DESIGN	40	DRAWN BY	JB	DART AEROSPACE LTD HAWKESBURY, ONTARIO, CANADA		REV. C
CHECKED	PH	APPROVED	PH	DRAWING NO.	D3196	SHEET 1 OF 3
DATE	06.10.31			TITLE	BAR	SCALE 1:4
A		03.06.25		NEW ISSUE		
B		06.09.25		ADD D3196-5		
C		06.10.31		ADD SLOTS ON -1; REMOVED -5

DRAWING NO. D3196	TITLE BAR	REV. C	DART AEROSPACE LTD ENGINEERING ORDER		D.E.O. NO. D3196-C-1	SHEET NO. SHEET 1 OF 2	SCALE NTS
DRAWN ASS	CHECKED	MFG. APPR.	APPROVED		DE APPR.		
DATE 08.08.27	DATE 08.08.28	DATE 08.08.29	DATE 08.08.29	DATE 08.08.29	DATE 08.09.04

DART AEROSPACE LTD		Work Order:	118832
Description: Bar		Part Number:	D3196-3
Inspection Dwg: D3196	Rev: C	Page 1 of 1

D3196-1 BAR

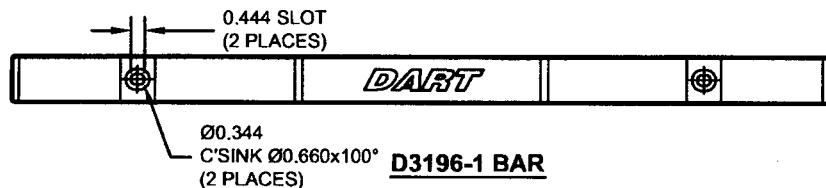
SHEET 1 MODIFY SLOT DIMENSIONING ON D3196-1 AS SHOWN:

NOTE: THIS CHANGE HAS BEEN DONE TO CLARIFY SLOT DIMENSIONS ONLY. NO CHANGES HAVE BEEN MADE TO THE PARTS
SEE NCR 08-051 FOR FURTHER INFORMATION
ALL OTHER INFORMATION REMAINS UNCHANGED

D3196-3 BAR

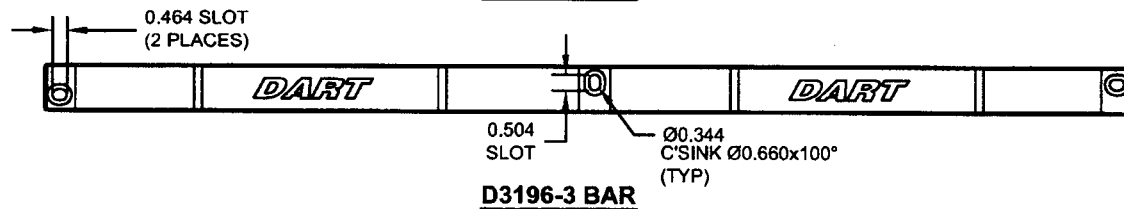
SHEET 2 MODIFY SLOT DIMENSIONING ON D3196-3 AS SHOWN:

D3196-4 BAR

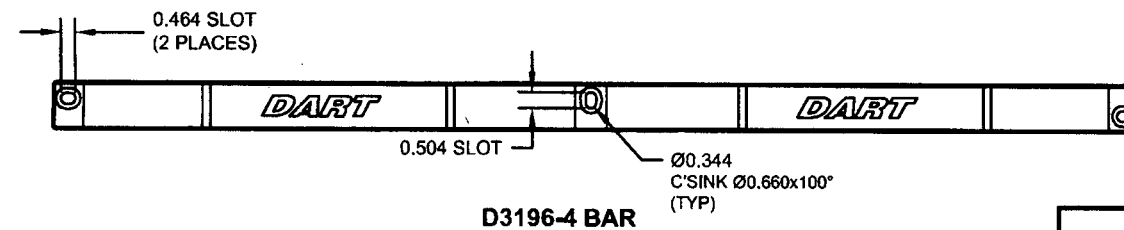
SHEET 3 MODIFY SLOT DIMENSIONING ON D3196-4 AS SHOWN:
